STAFF RECOMMENDATION

2403 Barton Avenue

August 17, 2016

Application: Demolition; New construction – addition and outbuilding

HOUSE - EAST ELEVATION

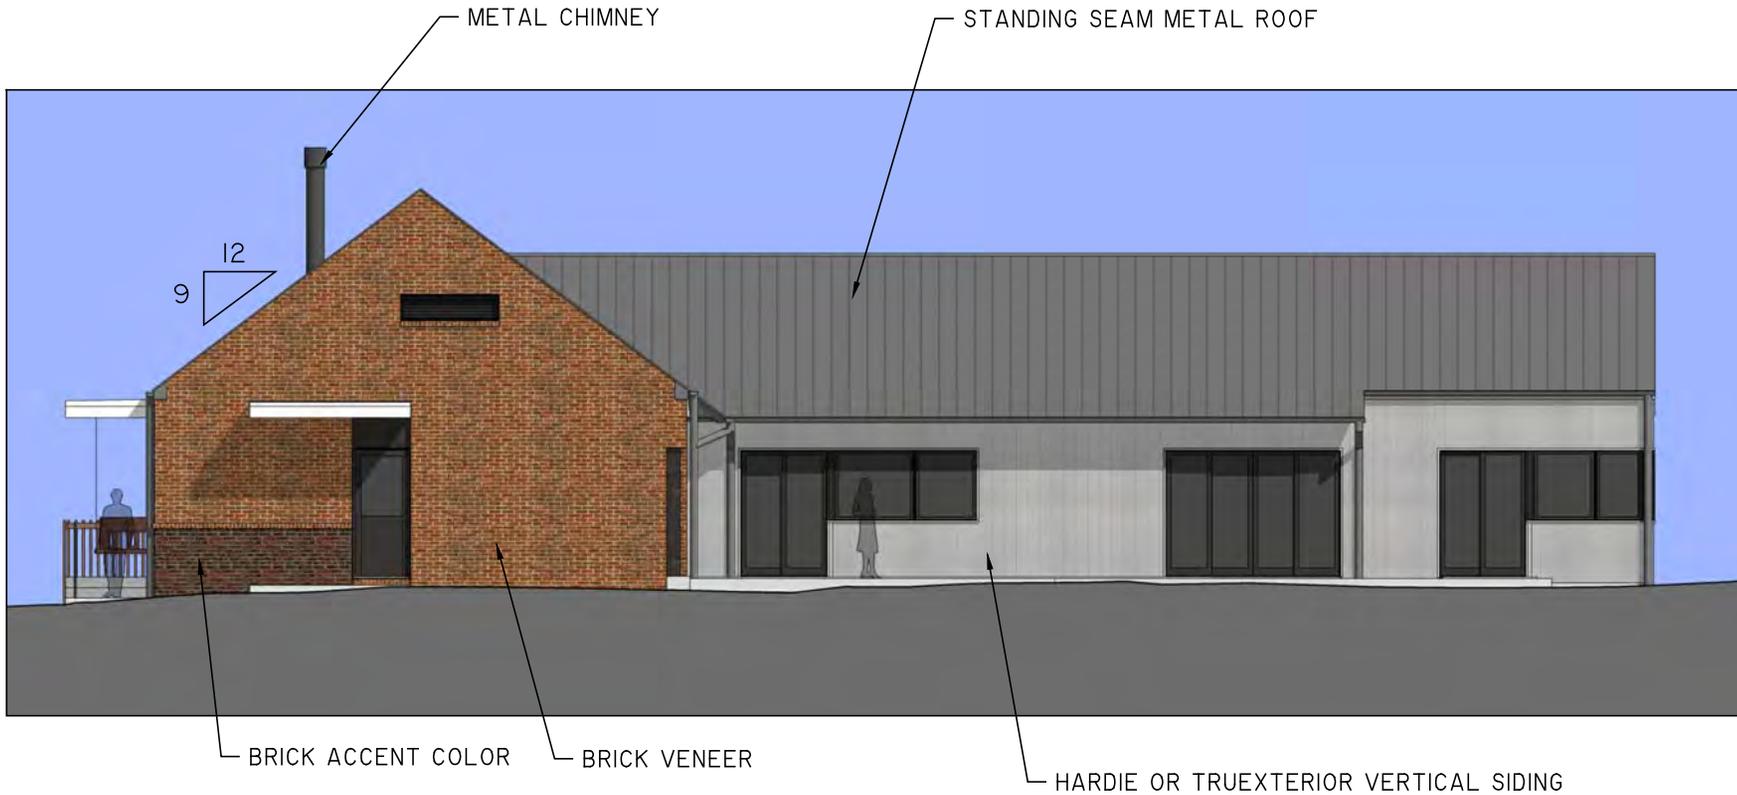
Proportion and Rhythm of Openings: Flanking the recessed vestibule on the front elevation are two window features. The one on the right is a single large picture window, and though the window is square it is set in a rectangular opening with a panel above to give the appearance of verticality. On the left side is a series of four windows which read as modern interpretation of a ribbon of windows. Staff finds the project to meet section II.B.1.g of the design guidelines. The side elevations have appropriate proportions and there will be no large expanses of wall space without a window or door opening, meeting that guideline.

- The floor level shall be constructed at height consistent with adjacent houses, to be verified by Staff;
- Brick color and texture shall be approved by staff;
- Window and door selections on the house and outbuilding shall be approved by staff;
- Front porch railings shall be approved by Staff;
- The right side driveway shall extend at least to the mid-point of the house; and
- The HVAC shall be located at or behind the midpoint of the building.
